**LAKE MANITOBA AND LAKE ST. MARTIN OUTLET CHANNELS PROJECT
SUPPLEMENTAL SUBMISSION**

**MTI's response to IAAC's Attachment 1: Outstanding Information in
Response to Information Request Round 1 (Amended)
(dated June 6, 2022 and amended June 22, 2022)**

Attachment 1: Outstanding Information in Response to Information Request Round 1 (Amended)

| MAY 2017 | | PLATE D6-5 | | REV: 0 |

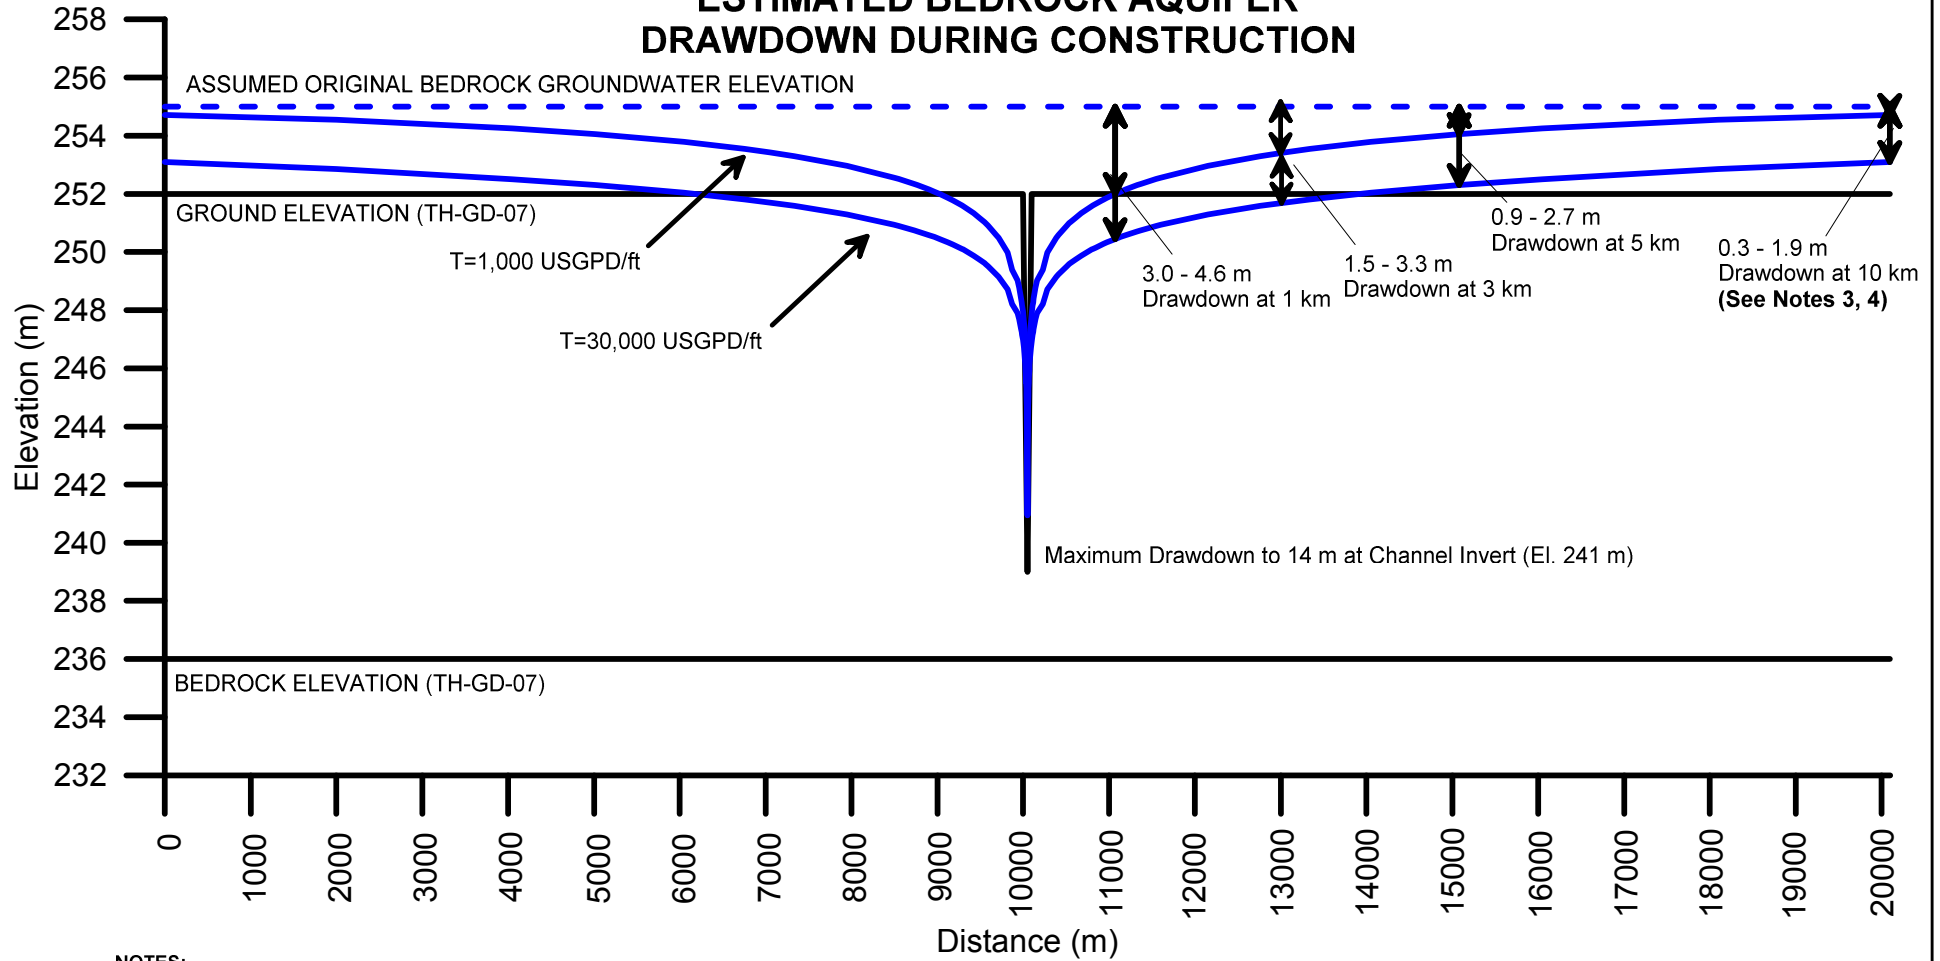
| # | Item | Comment | Request | Response (revisions shown in red) |
|----|---------------------------------------|---|---|---|
| 11 | IAAC-27: Missing Information | The Response refers to Plates D6-5 and D6-6 in Appendix IAAC-27A. The Appendix is missing. | Provide Appendix IAAC-27A including the Plates that are referenced. | <p>Appendix IAAC-27A was missing in the formal filing.</p> <p>This information is included; see the Appendix 27A figure/plates</p> |

**APPENDIX 84A: VELOCITY CONTOUR MAPS FOR LAKE
ST. MARTIN ILLUSTRATING PASSAGE OF THE
2011 PEAK FLOWS FOR THE PRE- AND POST-
PROJECT ENVIRONMENT**

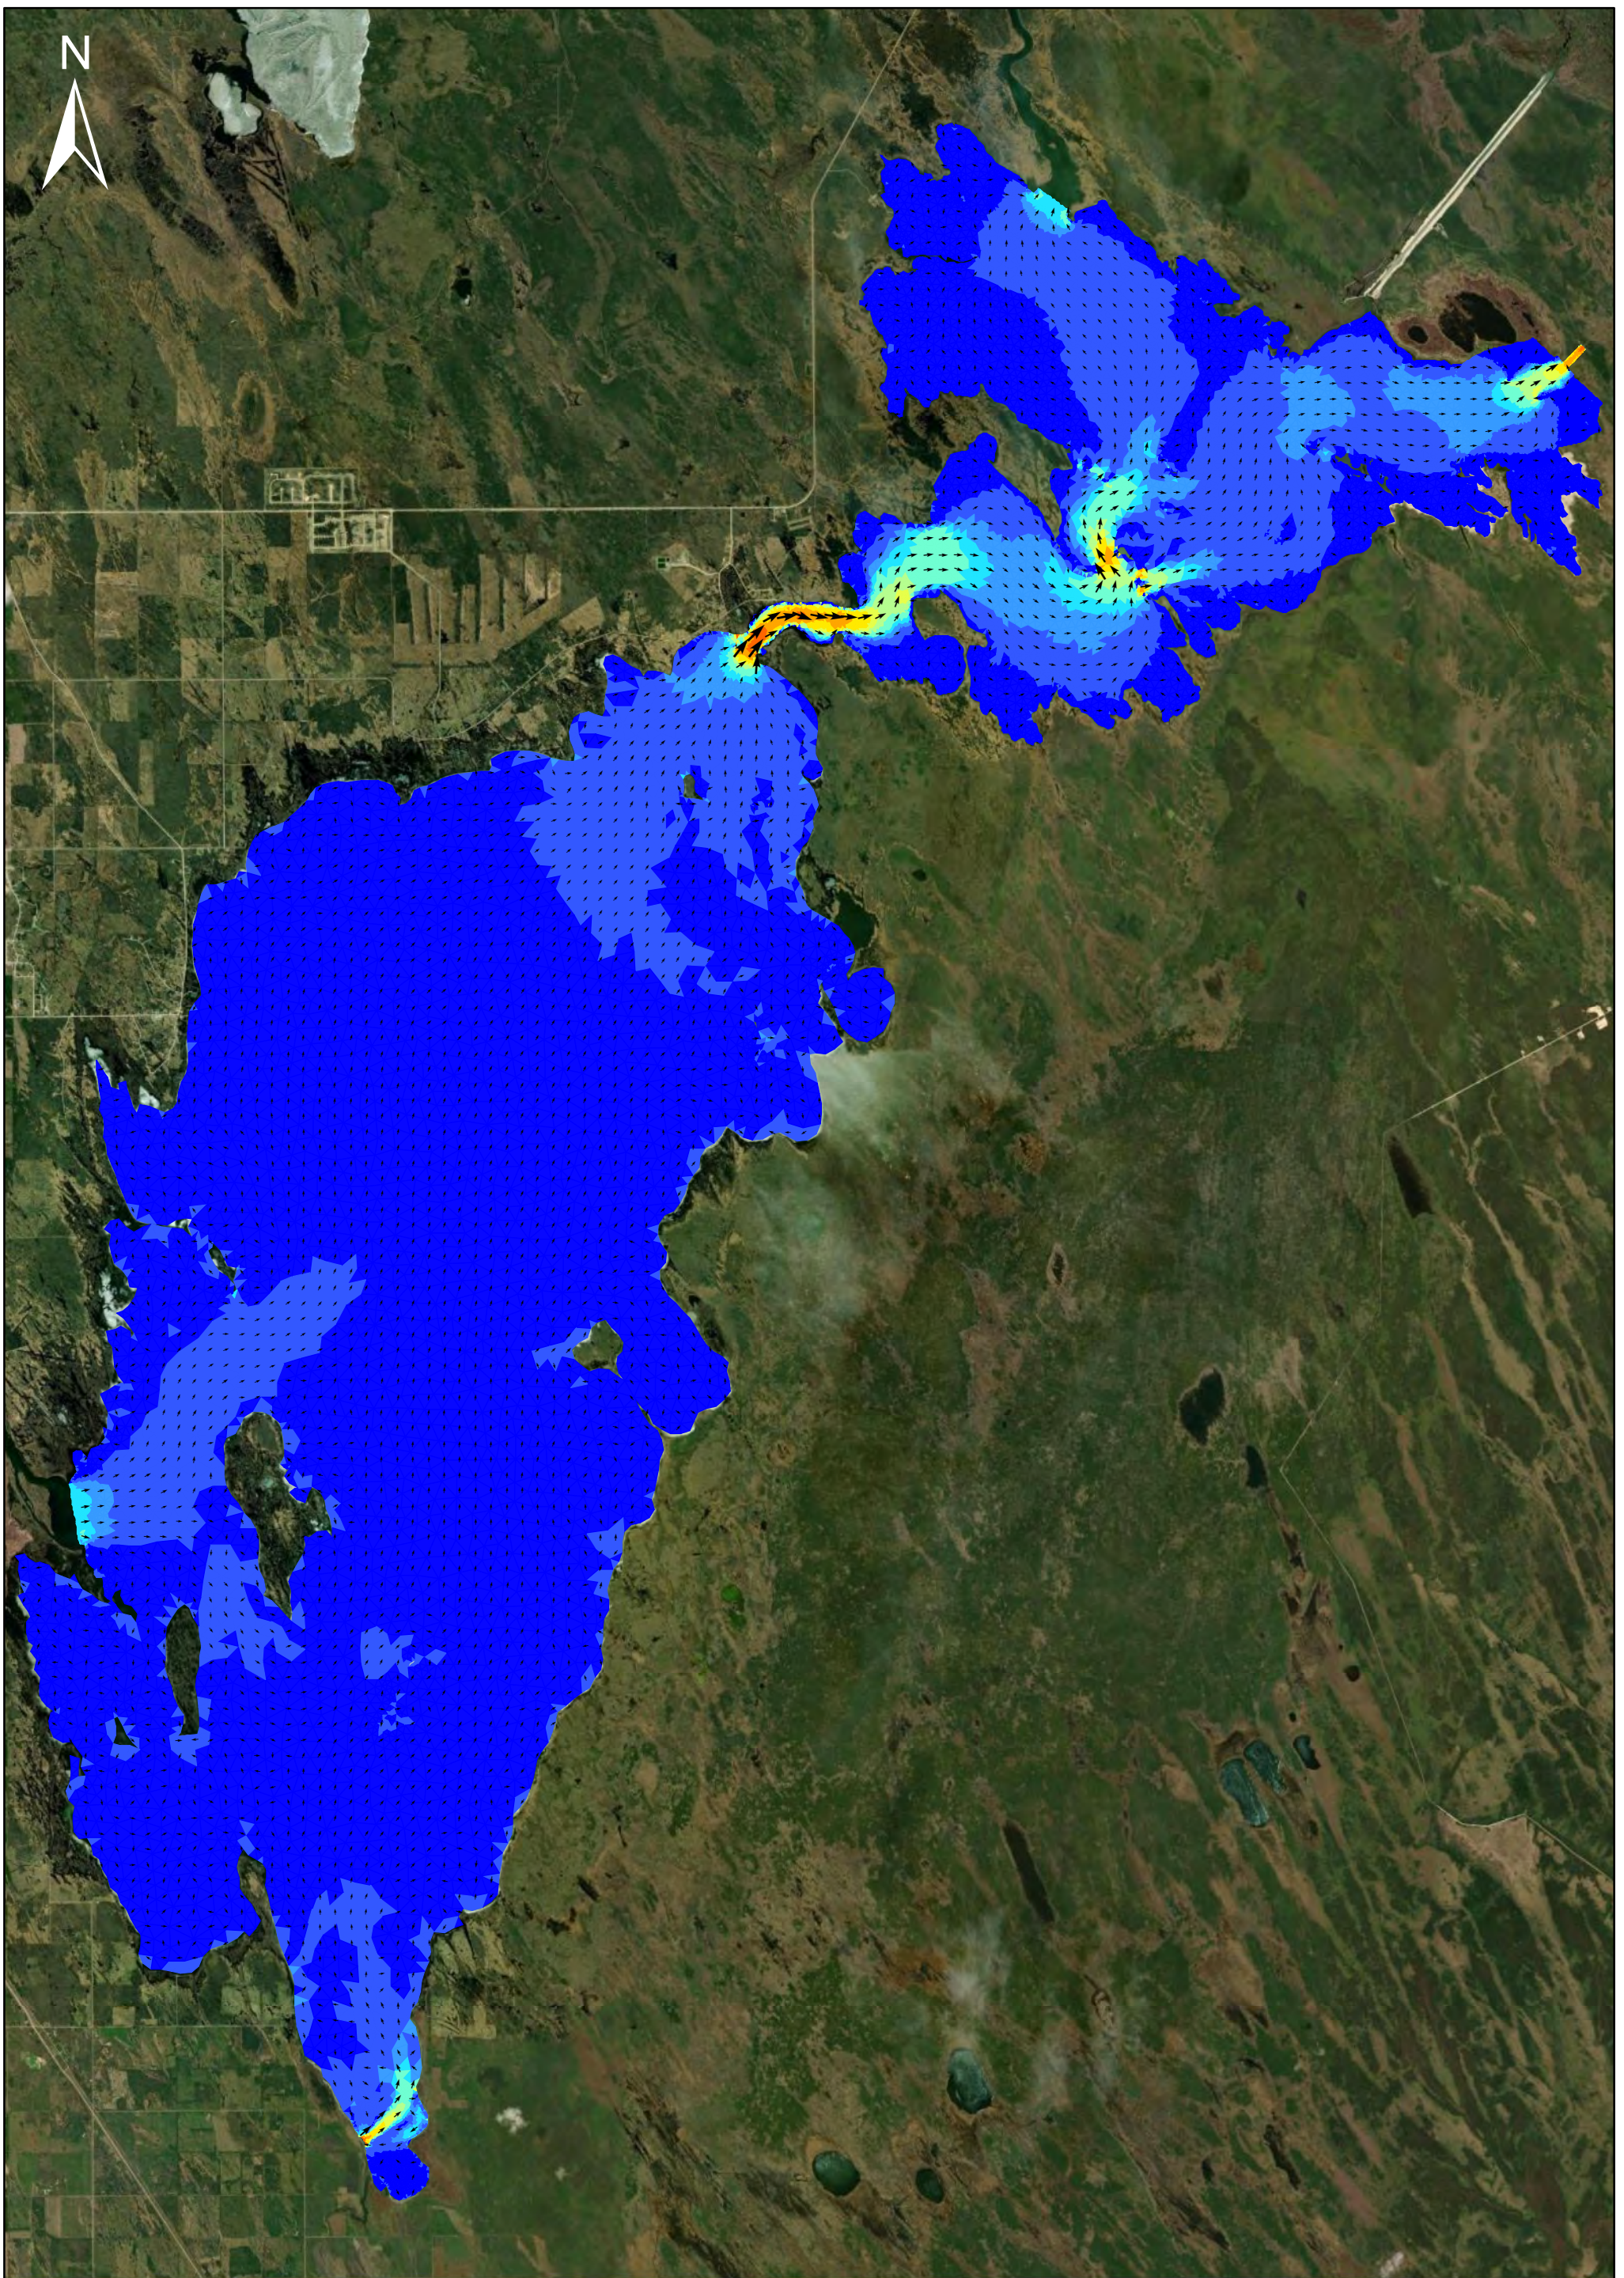
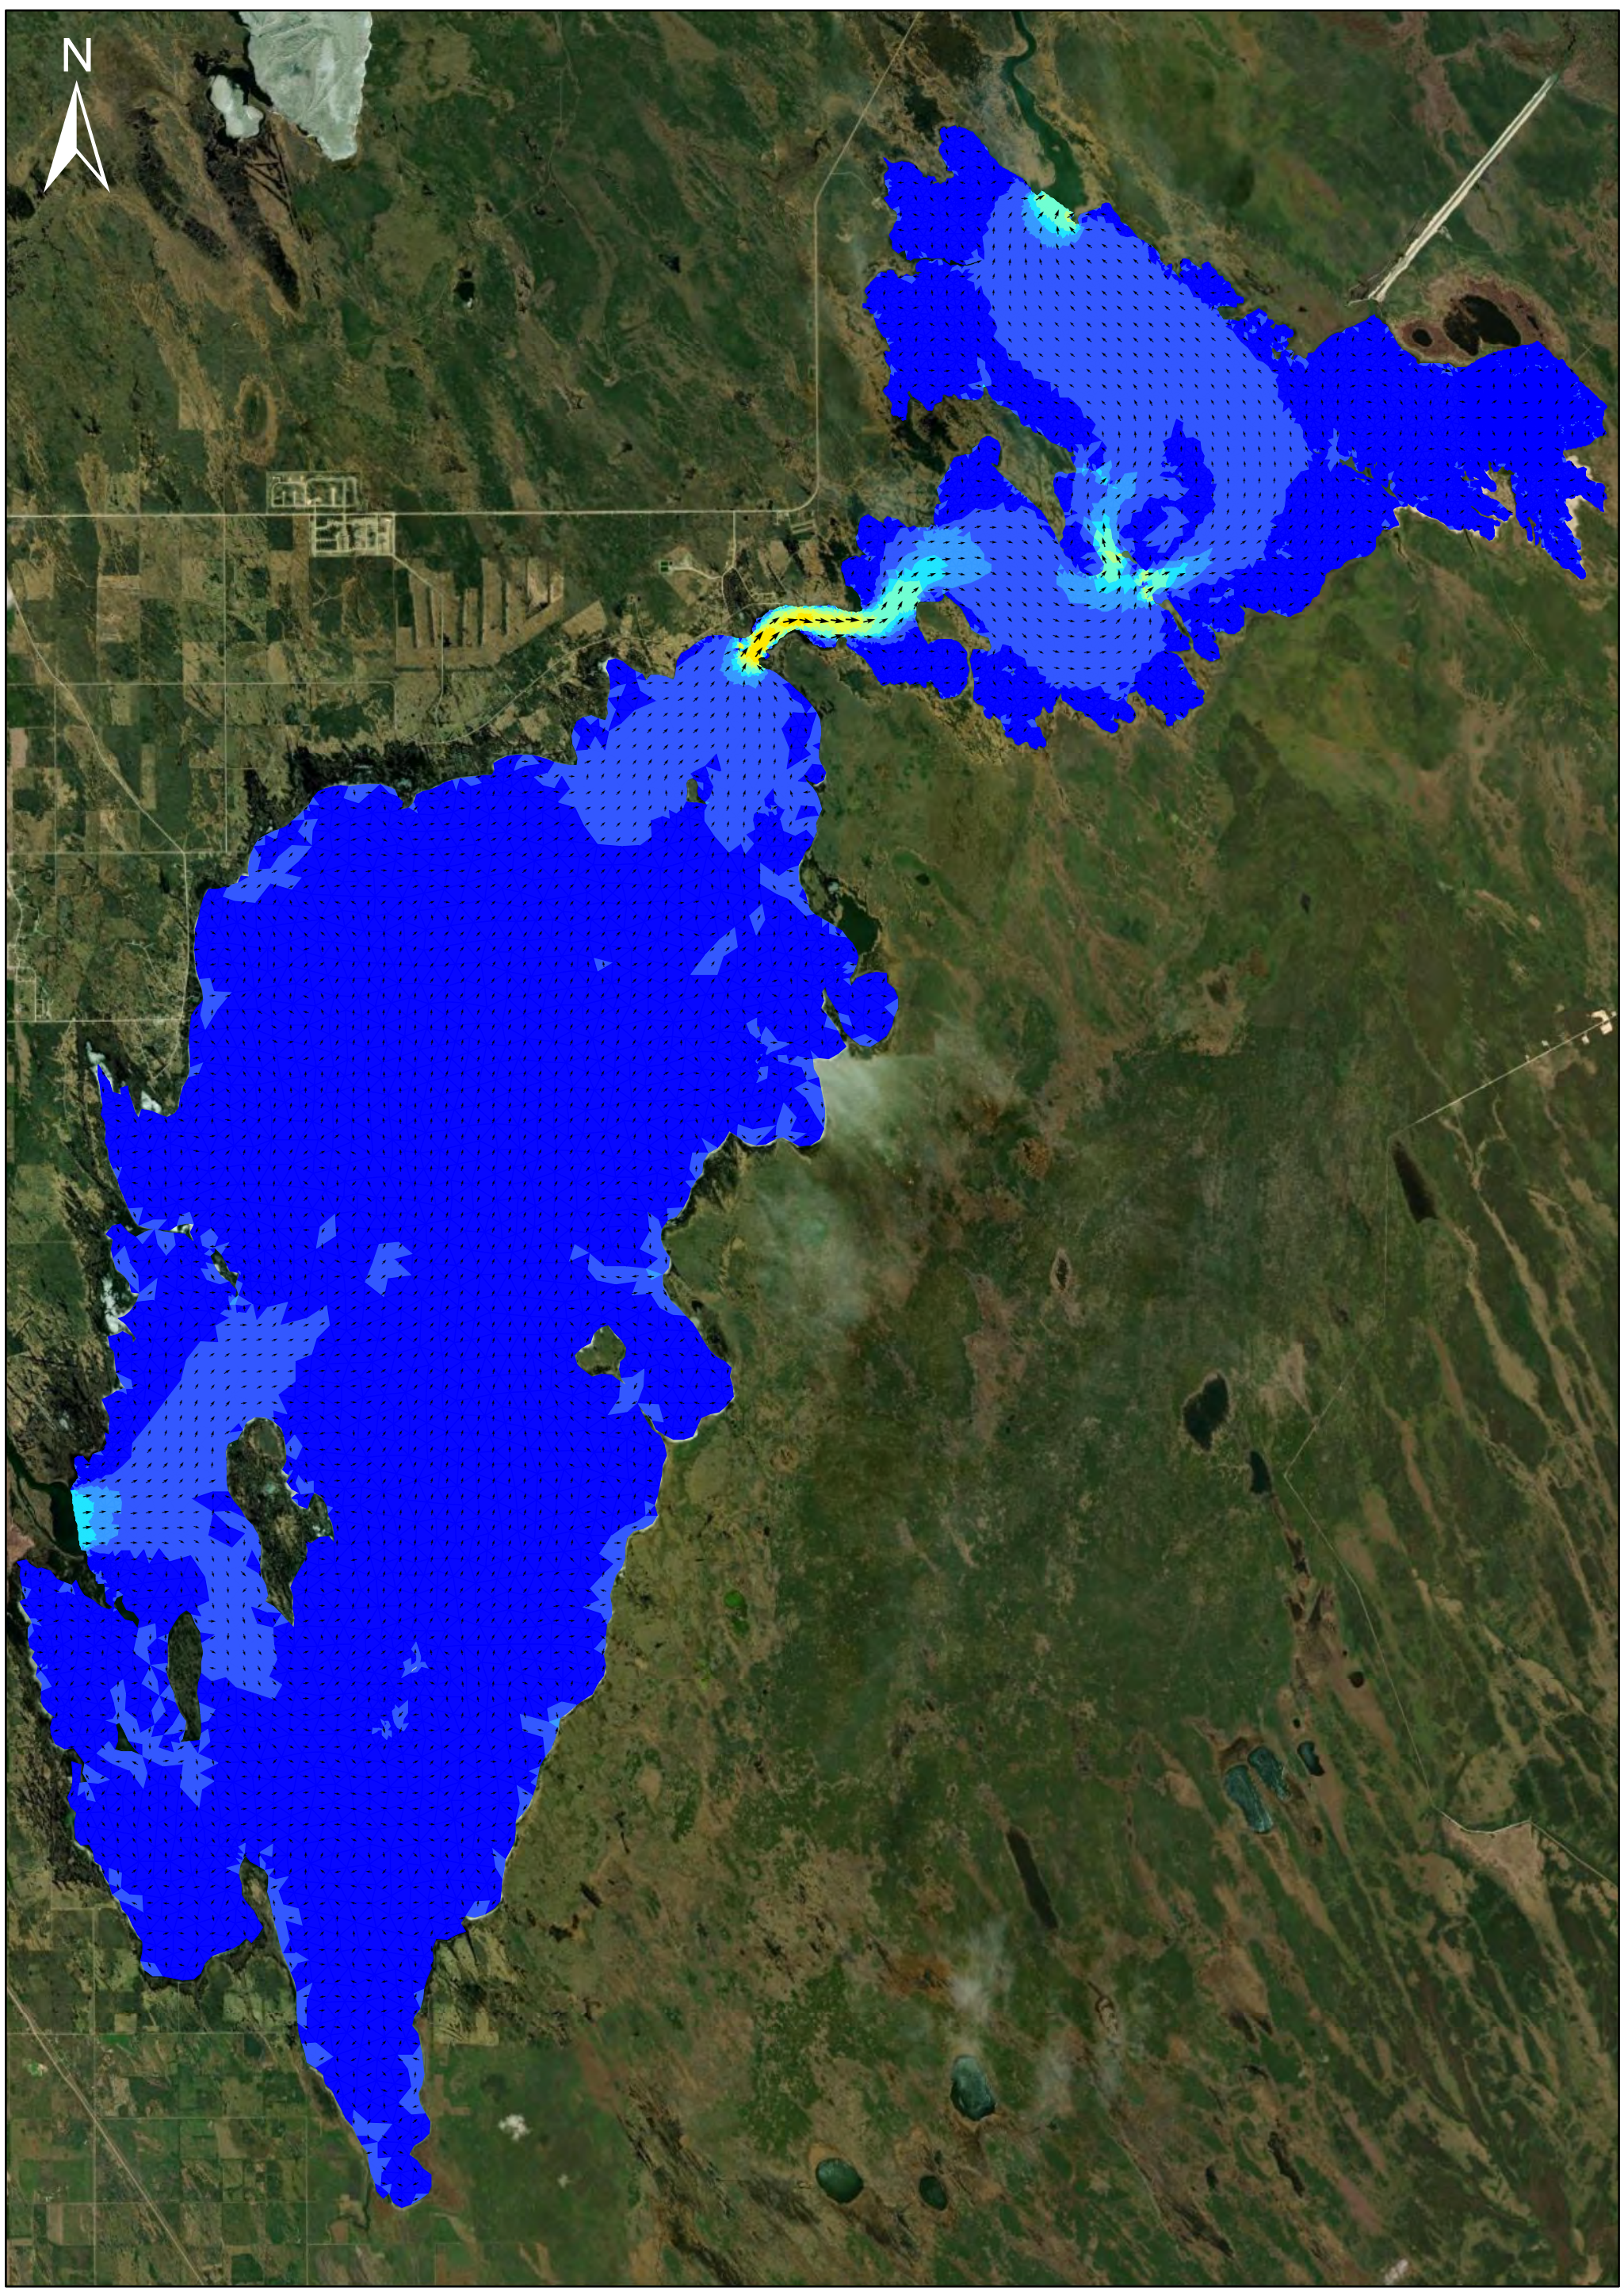
| # | Item | Comment | Request | Response (revisions shown in red) |
|----|---|--|---|---|
| 20 | IAAC-84: Missing Information | Appendix IAAC-84A appears to be missing. | Provide the missing information. | Appendix 84A: Velocity contour maps for Lake St. Martin illustrating passage of the 2011 peak flows for the pre- and post-Project environment are included in Appendix IAAC-84A This information is included; see the Appendix 84A velocity figures |
